APPLICATION NO.	FILING DATE	FIRST NAMED INVENTOR	ATTORNEY DOCKET NO.	CONFIRMATION NO.
09/841,570	04/24/2001	Gary Boccadutre	1647001	5425
7590 11/01/2005			EXAMINER	
HORST M. KASPER 13 FOREST DRIVE WARREN, NJ 07059			SHAKERI, HADI	
			ART UNIT	PAPER NUMBER
			3723

Office Action Summary	Application No. 09/841,570	Applicant(s) BOCCADUTRE ET AL.	
	Examiner Hadi Shakeri	Art Unit 3723

DETAILED ACTION

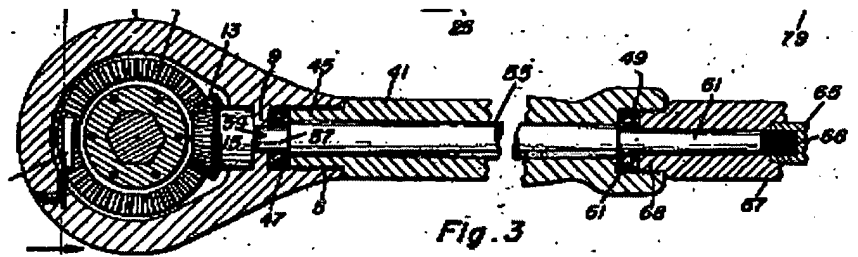
4. Claims 1, 3, 5 and 11 are rejected under 35 U.S.C. 102(b) as being anticipated by Lampke, US Patent No. 2,808,749.

Lampke discloses all the limitations of the above claims 1, i.e., power wrench comprising a handle containing a motor (e.g., 67); a ratchet extension (41) attached to the handle; a ratchet extension shaft (55) attached to the handle and

a ratchet head (1); and the ratchet head (1) attached to the extension and the shaft, wherein the extension and the shaft are removable; a plurality of removable extension (41, 67, 81) and a plurality of removable shafts (55, 77) each separately removable.

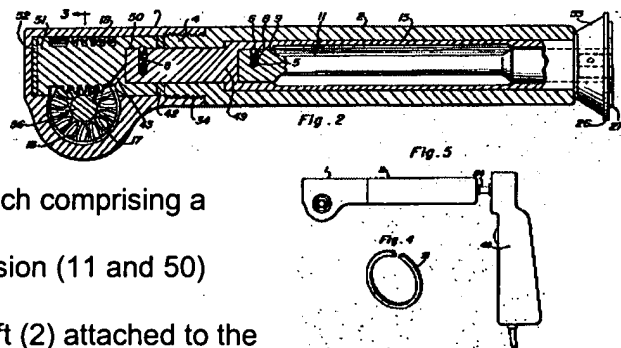
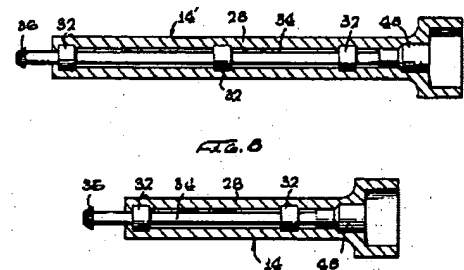
5. Claims 1, 3, 11-13, 17,19-22 and 27-31 are rejected under 35 U.S.C. 102(b) as being clearly anticipated by Hendrickson, US Patent No. 3,430,510.

Hendrickson discloses all the limitations of the above claims, i.e., power wrench comprising a handle containing a motor (48); a ratchet extension (11 and 50) attached to the handle; a ratchet extension shaft (2) attached to the handle and a ratchet head (1); and the ratchet head (1) attached to the extension and the shaft, wherein the extension and the shaft are removable, i.e., Fig. 2.

Regarding claims 12, 13, 17,19-22 and 27-31, a pneumatic motor as disclosed in (04:56) would inherently meet all of the limitations of claims 12, 17 and 19 including ratchet head having a socket mount (56) attached to the extension (4, 34) and the shaft (socket accommodating 49), first end of the shaft attached to the handle (at 26, 27, 53), wherein the extension (2) includes an interface collar, i.e., the end adjacent to (53) slipped over (50) at a first end and a head mount (4) at the second end; a drive tang (49) at the second end of the shaft; a ratchet head drive shaft (socket accommodating 49); a drive shaft (54) attached to the handle engaging a

drive socket (53) (see phantom lines Fig. 2); ratchet head being demountable (34); extension (2) being tubular (03:41); and the shaft is solid rod (11 and/or 15, i.e., solid and, a thin straight piece or bar of material); wherein the shaft is connected to the pneumatic drive (at 53) and the socket mount (56) is rotationally transferring connected to the shaft (at 49 and/or 9); wherein the shaft is disposed in the extension freely rotating; wherein the extension (2) surrounds the shaft (11) without contact; and wherein the extension (2) and the shaft (11 and/or 15) are separate elements.
